**COMMONWEALTH OF KENTUCKY
TRANSPORTATION CABINET**
Frankfort, Kentucky 40622
www.transportation.ky.gov/

CALL NO. 301
CONTRACT ID NO. 171239
ADDENDUM # 1

Subject: Menifee County, FD04 SPP 083 0036 002-005
Letting September 29, 2017

- (1) Revised - Plans - R2D, R5, R9, R23, R44, & R45
- (2) Revised - Bid Items - Pages 74-75 of 75

COUNTY OF	ITEM NO.	SHEET NO.
MENIFEE	10-8001.10	R45

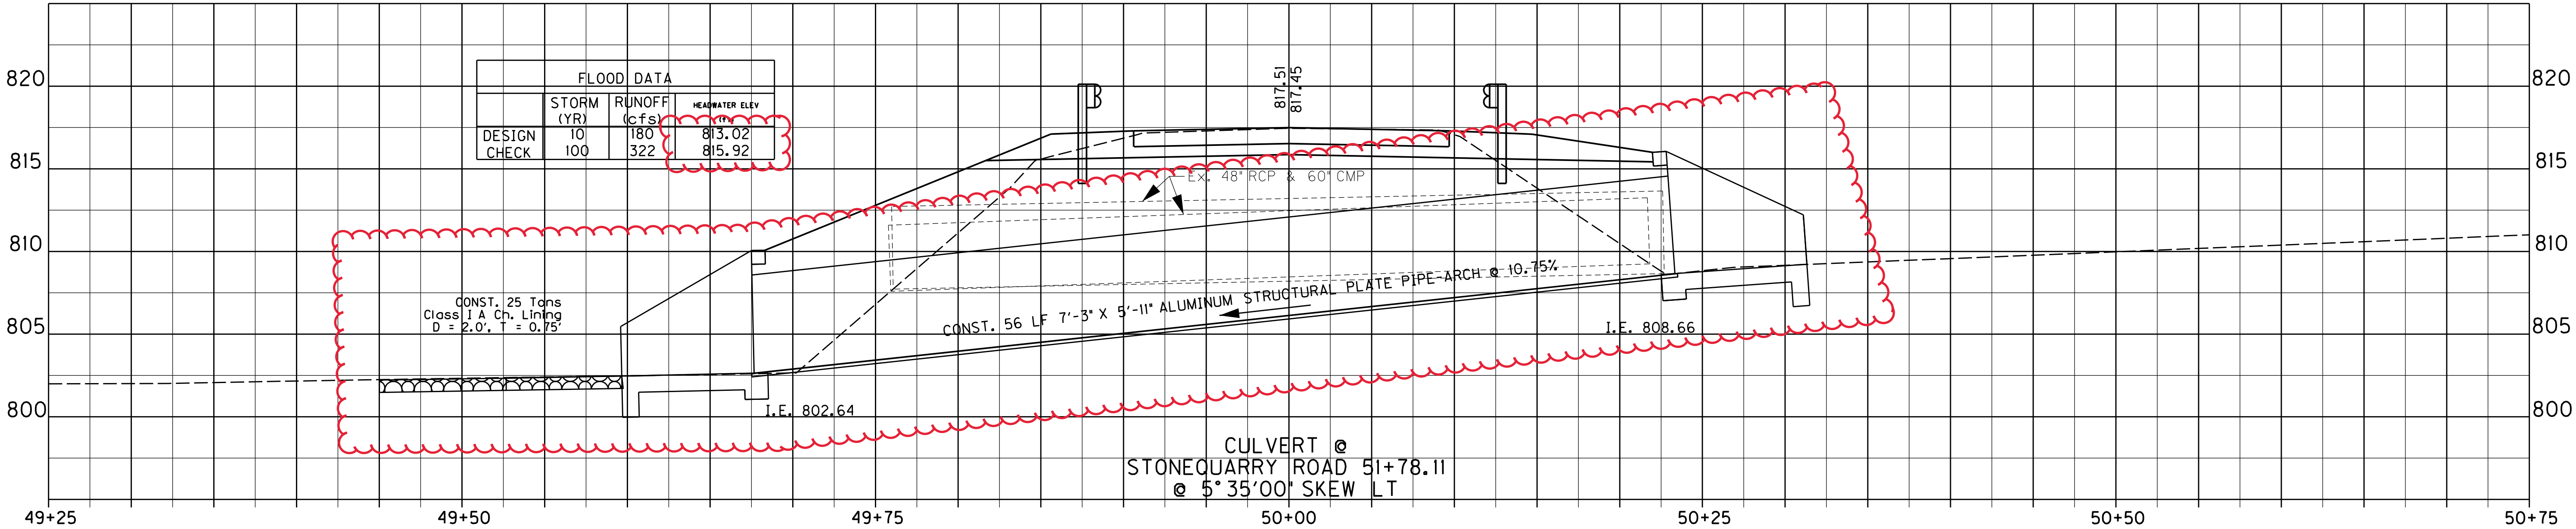
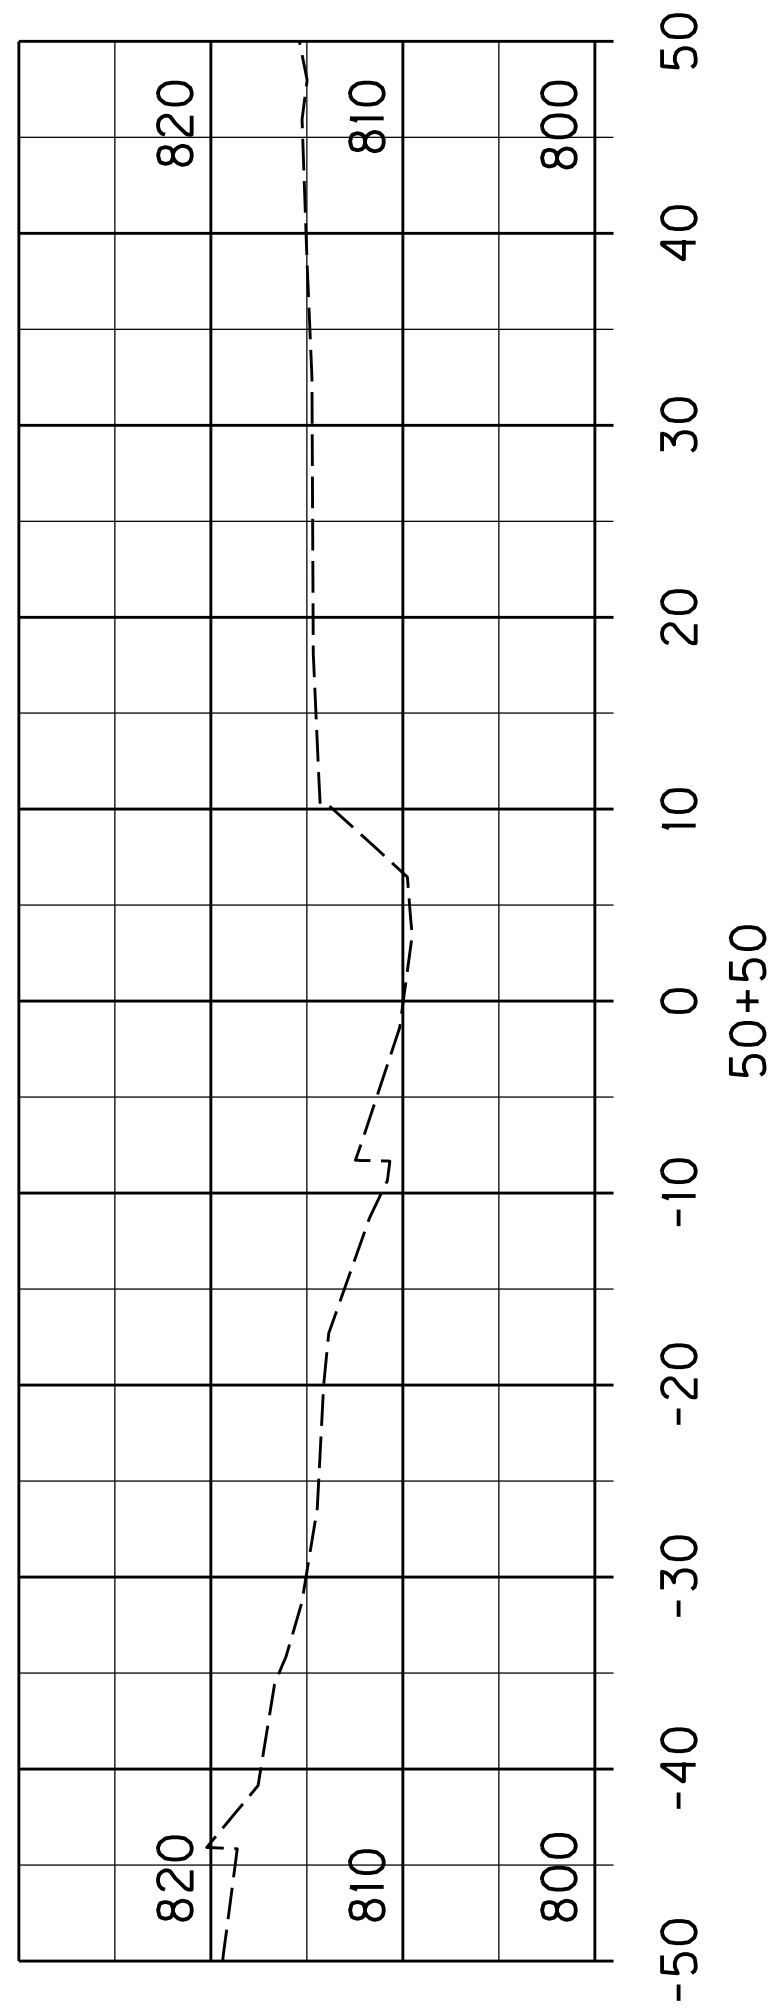
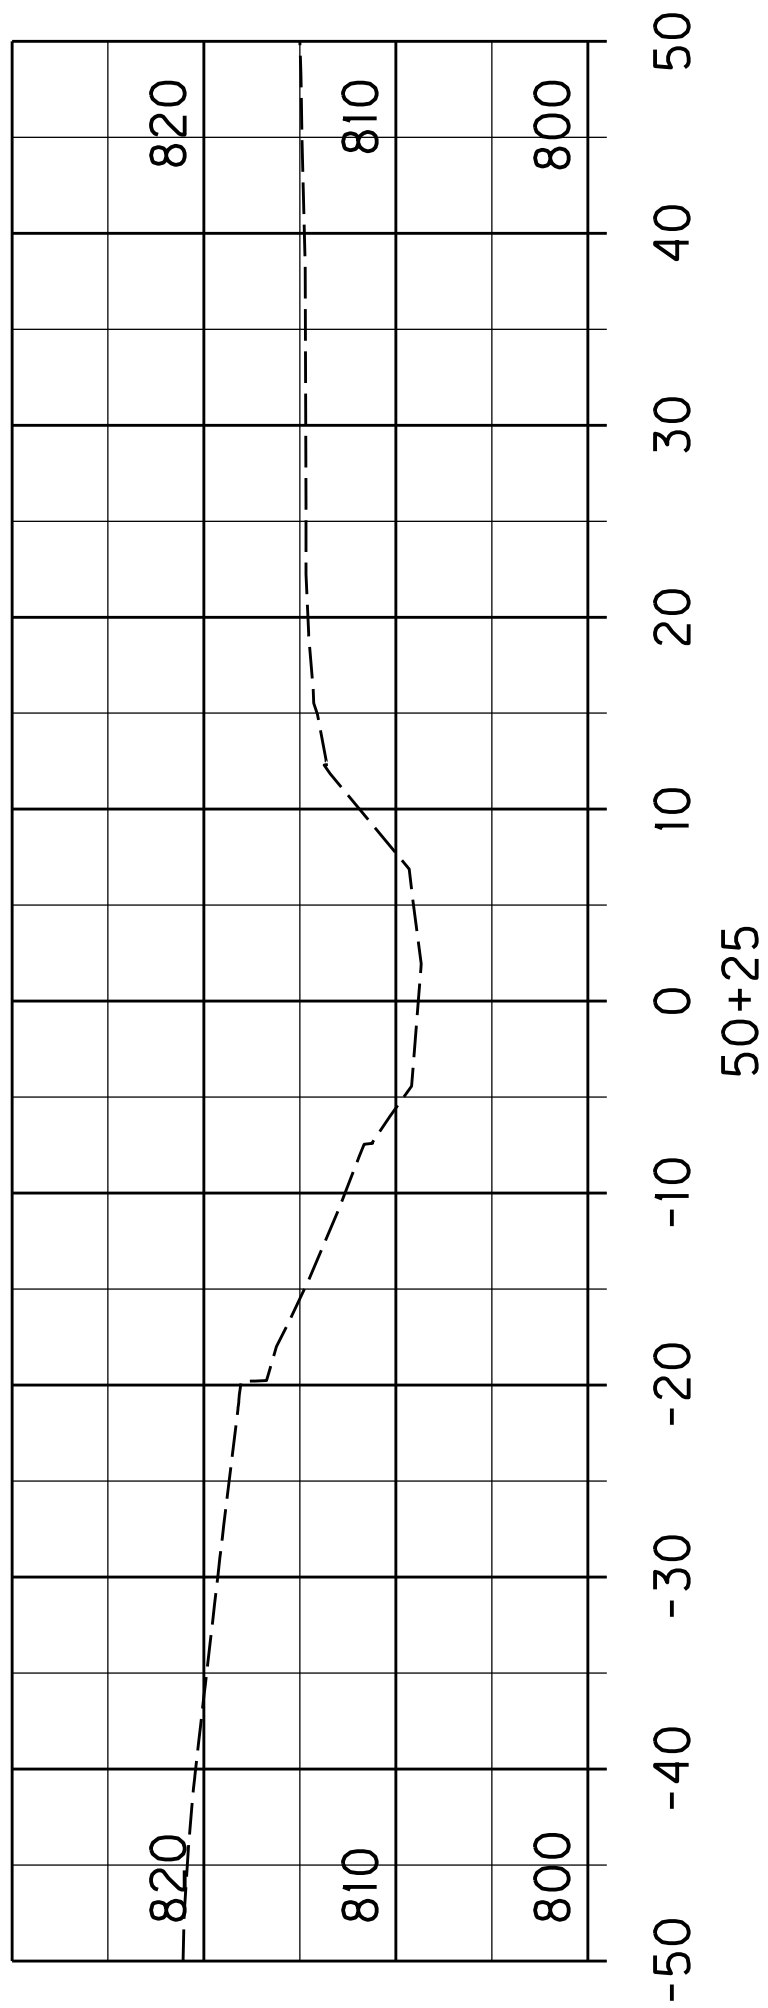
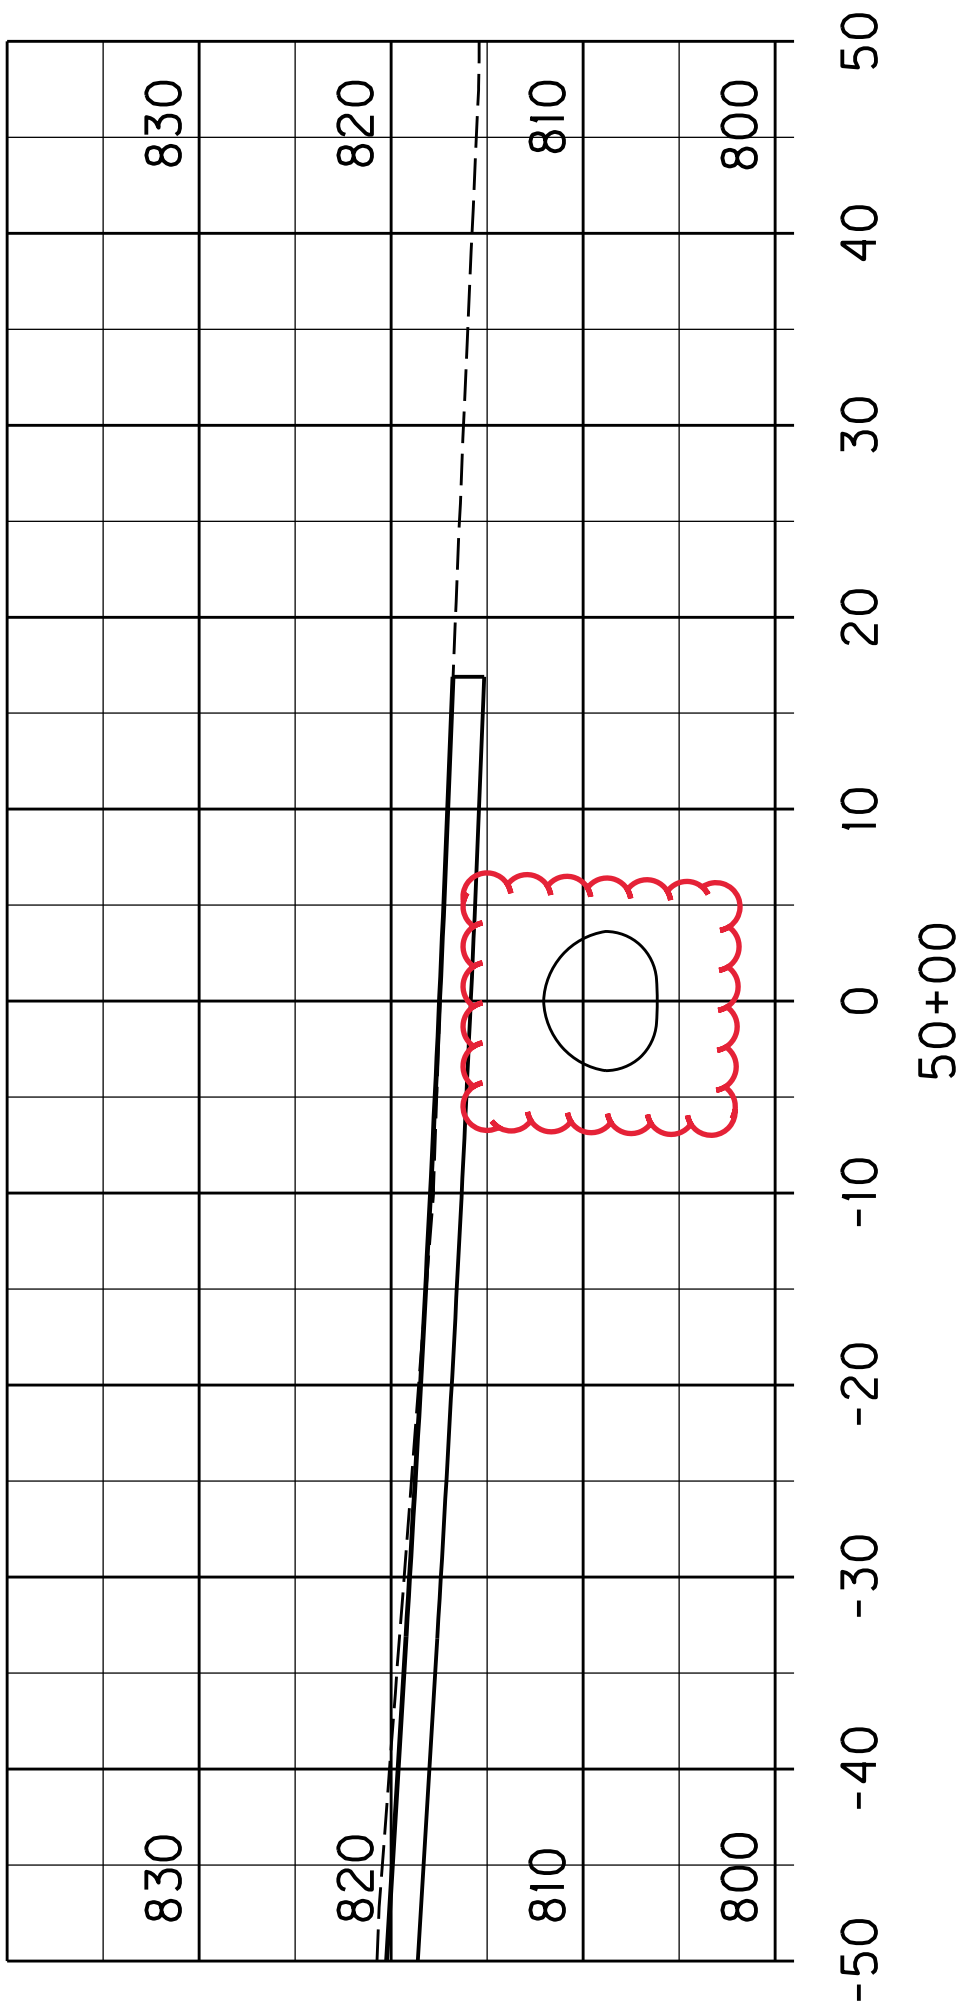
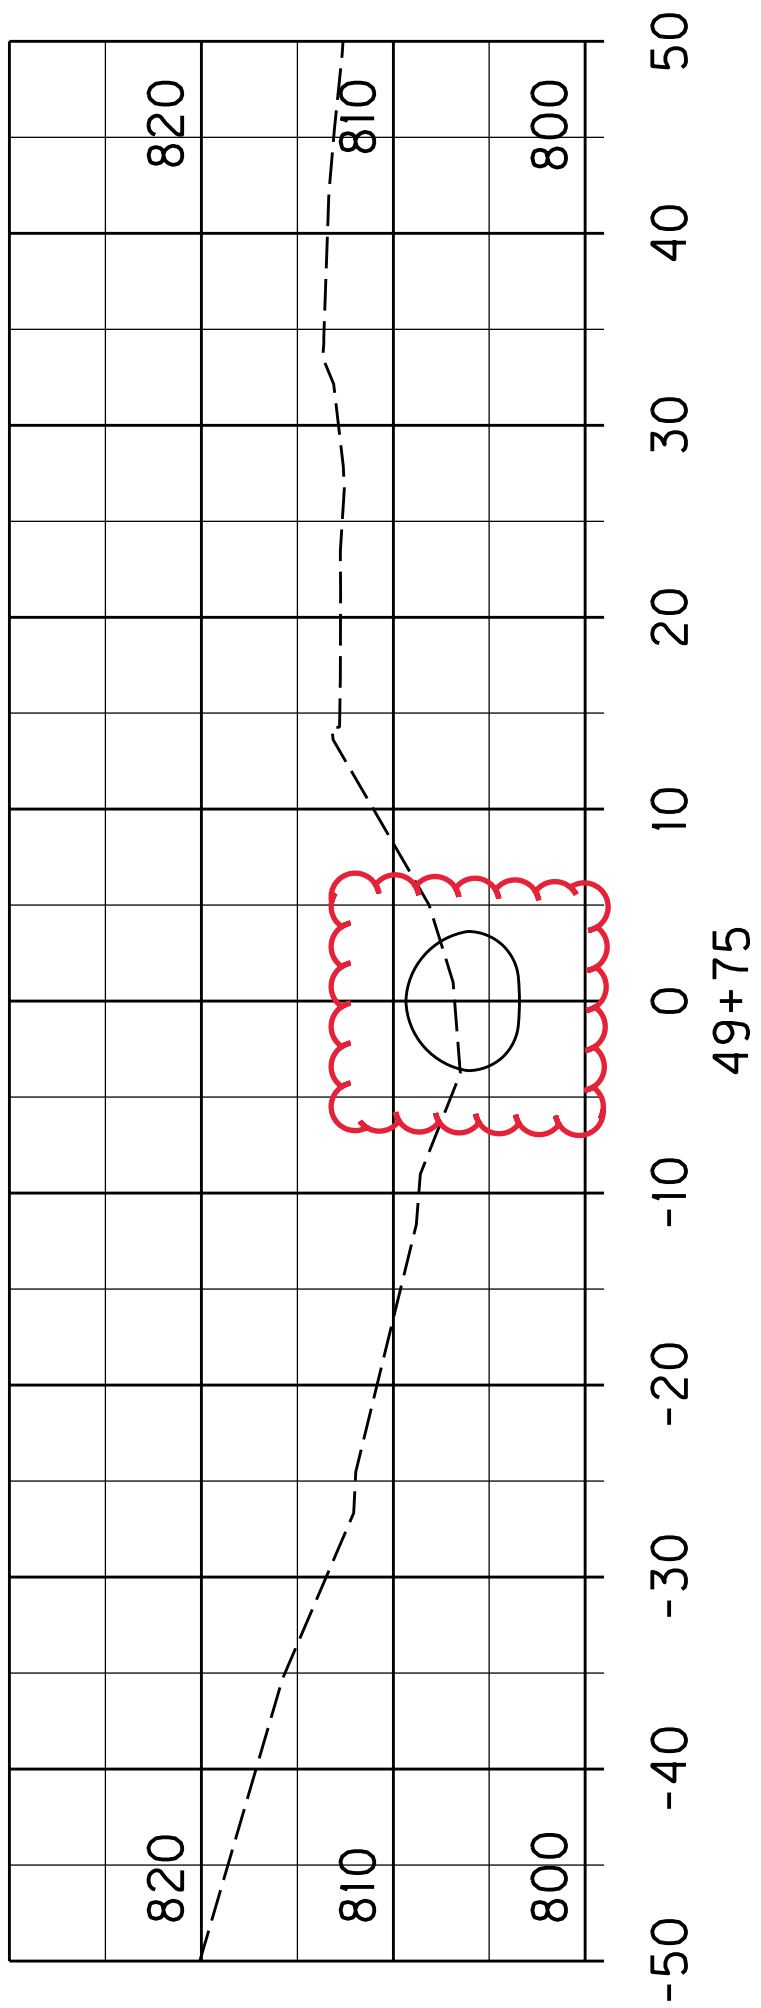
REVISED 09/18/2017
